JDSU 211x Remote Interface

Rev 0.1

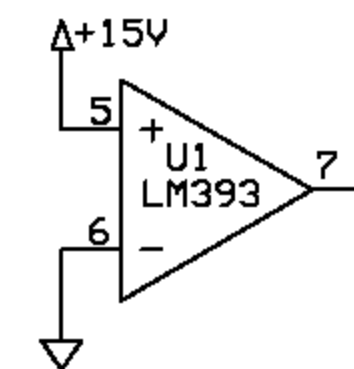
NOTES
 R5 TO BE ADJUSTED FOR 10:1 DIVIDE
 ADJUST R6 SO THAT U1-3 IS 0.5V
 FIXED SWAP OF PINS 8 AND 9 - Sam
